RS-20-139

Clinton Power Station, Unit 1  
Facility Operating License No. NPF-62  
NRC Docket No. 50-461

Subject: Response to Request for Additional Information Regarding License Amendment Requests to Adopt TSTF-505, Revision 2, and 10 CFR 50.69

**TABLE APLC-01-2  
SEISMIC PENALTY SENSITIVITY ON RICT CALCULATIONS**

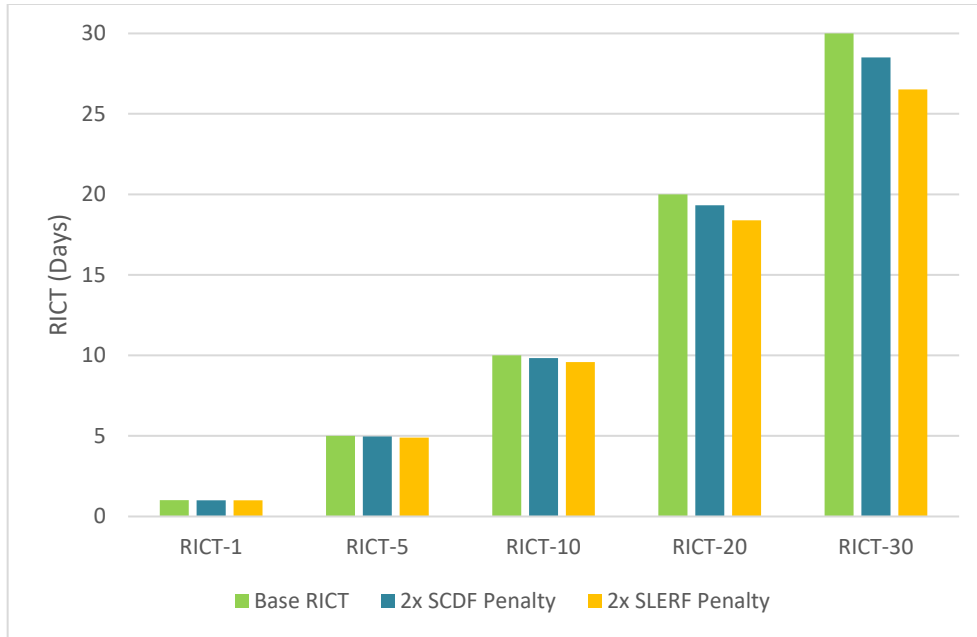
The penalty factors are a small percentage of the total  $\Delta$ CDF and  $\Delta$ LERF associated with RICTs, especially for the shorter timeframe RICTs. Increasing the penalty factor would have a very small impact on the RICTs for risk significant configurations (i.e., short RICTs). For example, Table APLC-01-2 and Figure APLC-01-1 below show the impact of an assumed doubling of the Clinton SCDF and SLERF penalty factors submitted in the LAR.
